**Minor Variance**  
**COMMENTS TO THE COMMITTEE OF ADJUSTMENT**  
**Panel 1**

Site Address: 297 Clemow Avenue

File No.: D08-02-21/A-00309

Figure 1 Staff's review of the Streetscape Character for 297 Clemow Street

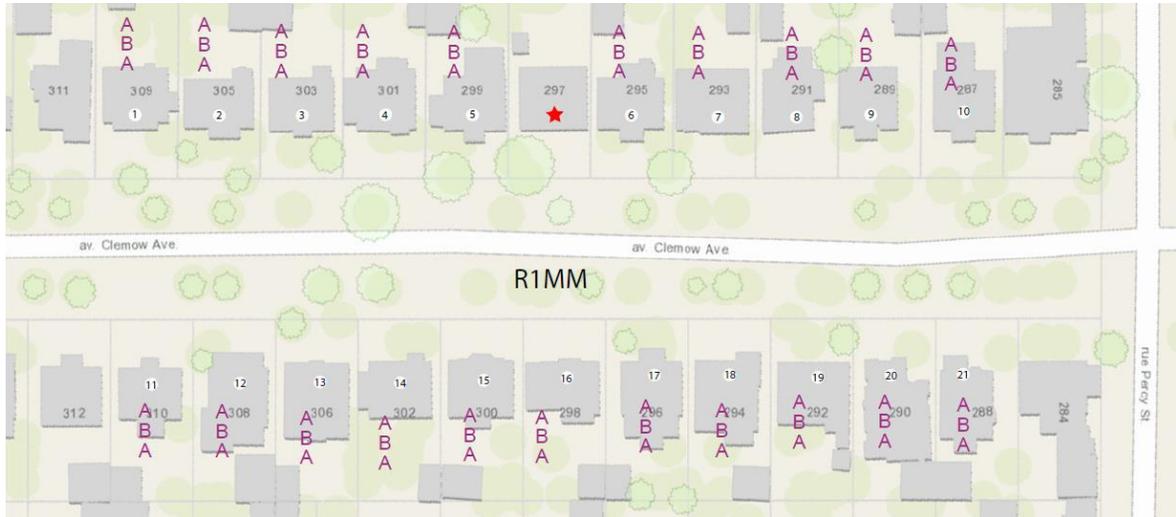
As the Applicant's cover letter correctly states, front yard parking is prohibited according to the Zoning By-law. The intent of Section 140 of the Zoning By-law and the Streetscape Character Analysis is that development should be consistent with the streetscape's dominant characteristics within the 21-lot analysis. The Streetscape Character Analysis, conducted by Staff, revealed that the dominant pattern for driveways and parking on this section of Clemow Avenue is shared single-wide driveways leading to parking spaces in the rear yards (see Figure 1). As per Staff's review of the immediate context from the subject site, legally established front yard parking on this section of Clemow Avenue is not the dominant pattern and therefore, a new front yard parking space is not permitted.

Staff note that there are a few properties along Clemow Avenue between Bronson Avenue and Percy Street which appear to have hard surfaced front lawns used for the purposes of front yard parking. For example, staff note that the aerial images on GeoOttawa suggest that the hard surfacing provided for 292 and 294 Clemow Avenue was implemented during the construction of 292 Clemow in 2017. No minor variances were filed with the Committee of Adjustment for these properties and therefore these properties are not included as examples of front yard parking within
